Certificate of Appropriateness BAR # 24-0038 218 West Market Street, TMP 330276000 Downtown ADC District Owner: Cavalier Hospitality LLC Applicant: Bob Pineo, Design Develop Project: Construction of multi-story hotel

Certificate of Appropriateness Application

BAR # 24-0038 218 West Market Street, Tax Parcel 330276000 Downtown ADC District Owner: Cavalier Hospitality LLC Applicant: Bob Pineo, Design Develop Project: New hotel

AC HOTEL by MARRIOTT - ADDENDUM 218 West Market Street, Charlottesville, VA

EAST ELEVATION 218 WEST MARKET STREET

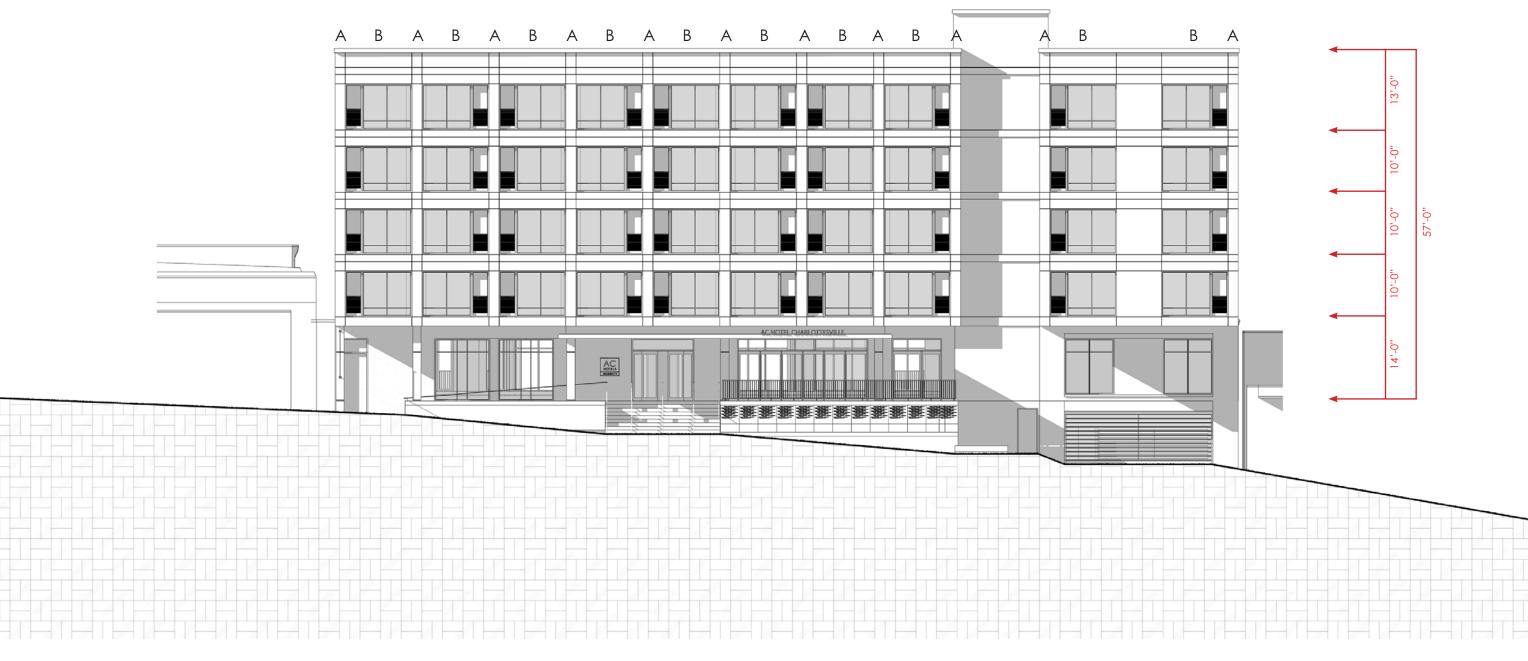
- Stucco reveals: Show detail, width, depth. Are they just reveals in the stucco, metal joints, something else?
- Provide typical window head/jamb/sill details and entire wall sections. Primarily, confirm the level of depth in the façade. (Not necessary to show technical details of the wall construction.)

- Indicate location of control joints and detail. For ex., are they ½" sealant joints colored to match the stucco and brick. Are they metal? Are they more substantial?

WINDOWS ON ALL FOUR SIDES OF THE BUILDING ARE ARRANGED IN A DELIBERATE A-B-A-B RHYTHM, CREATING A CONSISTENT AND BALANCED PATTERN THAT REINFORCES THE COHERENCE OF EACH FACADE. THIS RHYTHM IS MAINTAINED ACROSS THE ELEVATIONS WITH MINIMAL INTERRUPTION.

UPDATED SITE PLAN 218 WEST MARKET STREET

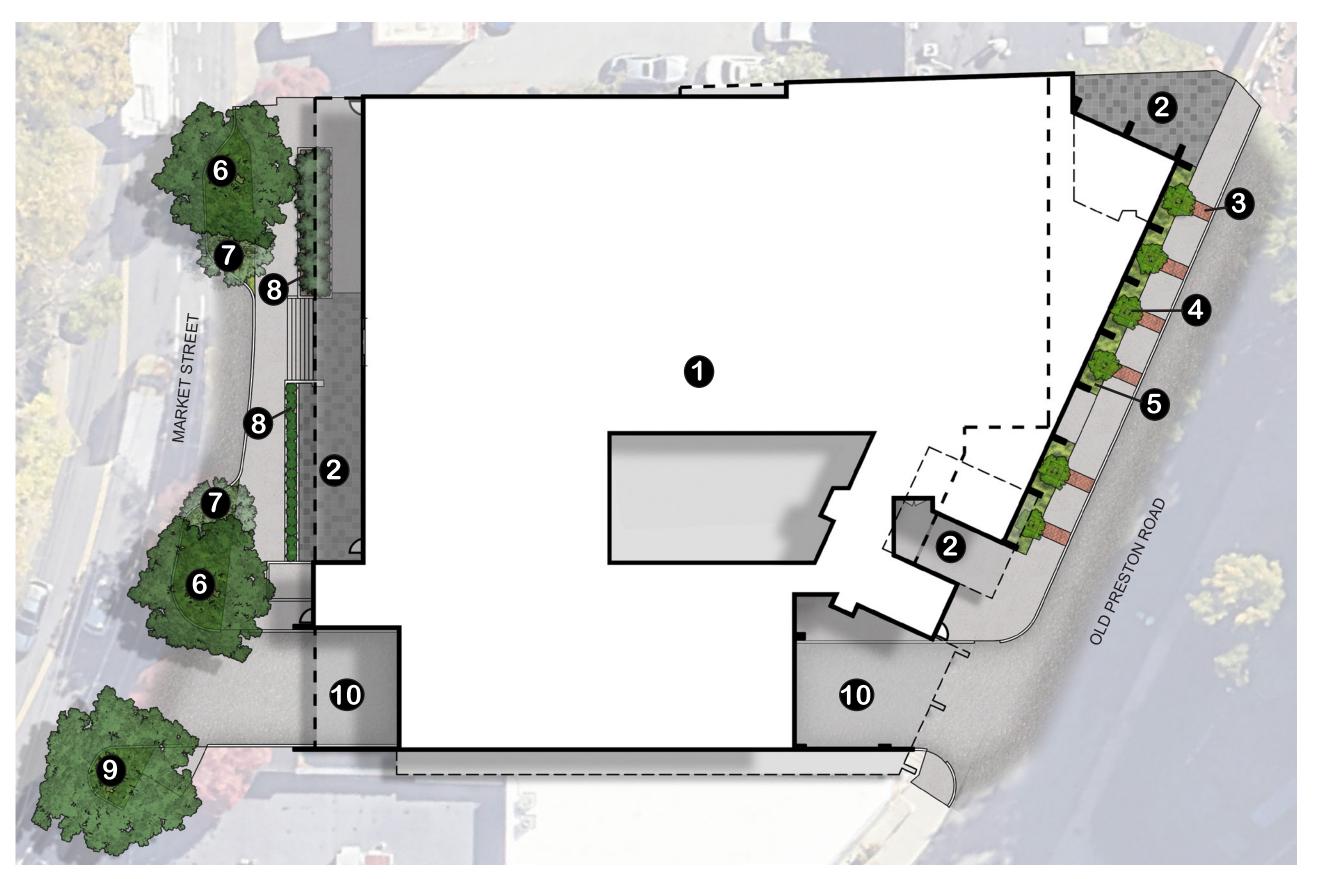
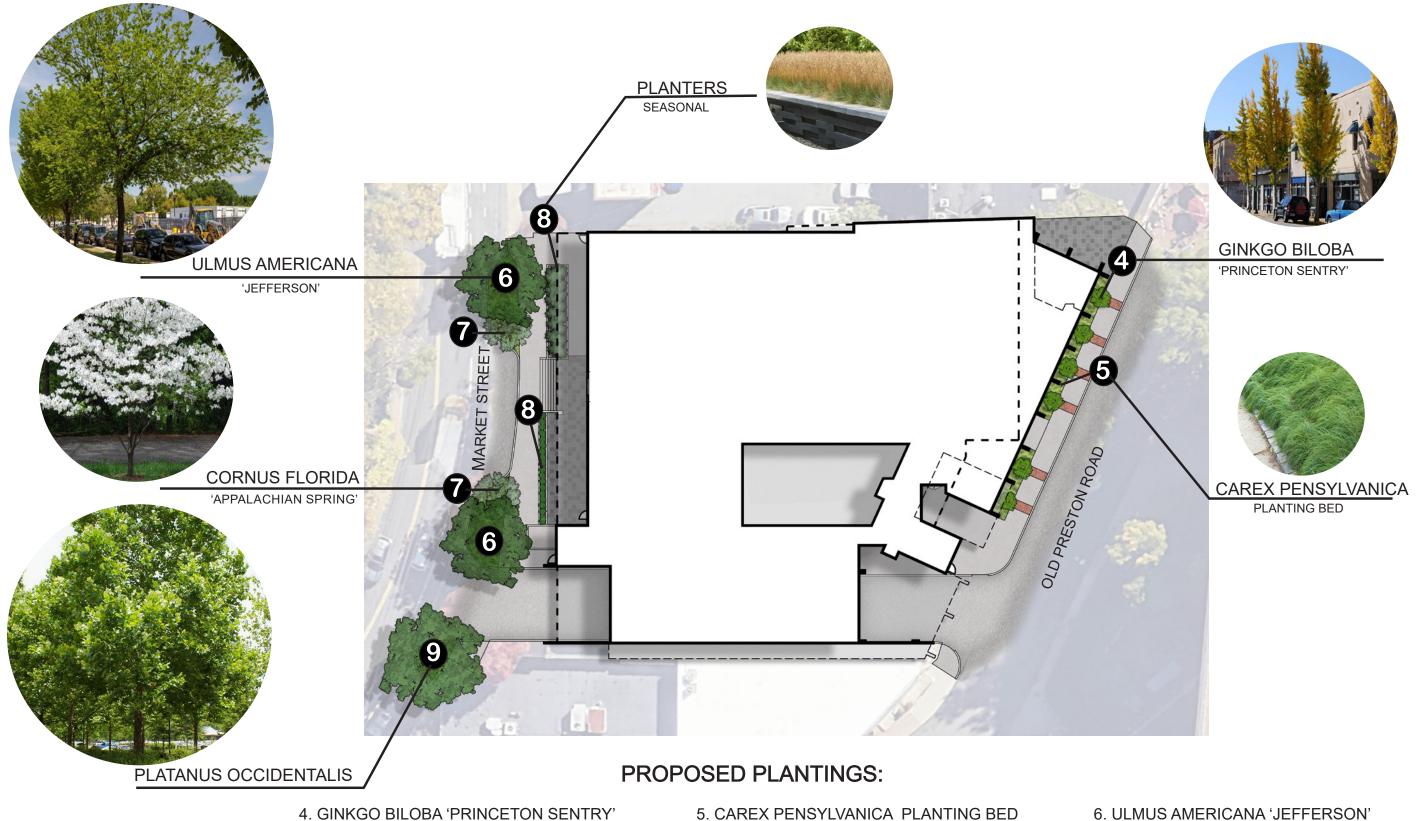
- Rooftop mechanical equipment screen: use material more permanent than PTP.
- Replace *Schizachyrium scoparium* 'Standing Ovation' (which likes full sun) with a shade tolerant plant palette.

- Reduce the height of the retaining wall(s).
- Add pedestrian lighting. For ex, BAR mentioned stair lights.

THE TALL BRICK WALL ALONG MARKET STREET HAS BEEN LOWERED AND BROKEN UP WITH PLANTERS AND PRIVACY SCREENS, CREATING A MORE INVITING EDGE AND PULLING THE PUBLIC PATIO BACK UNDER THE CANOPY. THE SAME PRIVACY SCREEN IS USED ON THE OLD PRESTON AVE SIDE TO SUBTLY DEFINE AND SCREEN THE PRIVATE HOTEL PATIO.

TWO TREES HAVE BEEN ADDED ON W. MARKET STREET TO SATISFY STREET TREE REQUIREMENTS. PLANTERS ALONG MARKET STREET WILL BE SEASONALLY PLANTED AND MAINTAINED BY THE OWNERS.

THIN BRICK TAB SYSTEM DETAIL

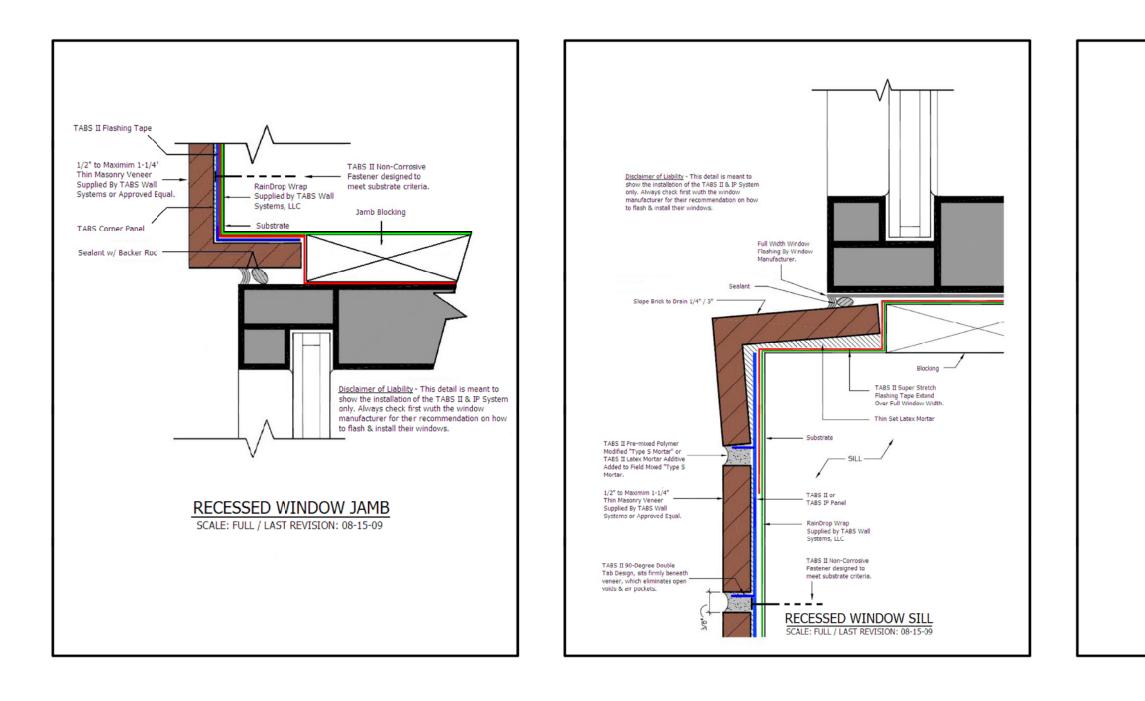
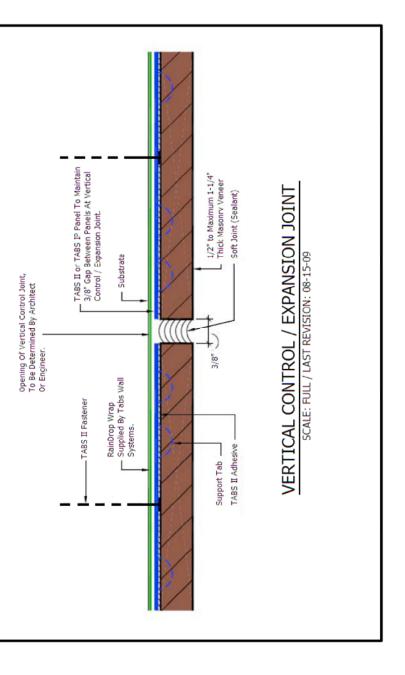
- Provide a spec for the thin brick system. Will it have TABS II Rain Screen or something equivalent behind this system?
- Provide a spec for the stucco. Don't need a CSI Masterpiece, provide description the various components/systems.
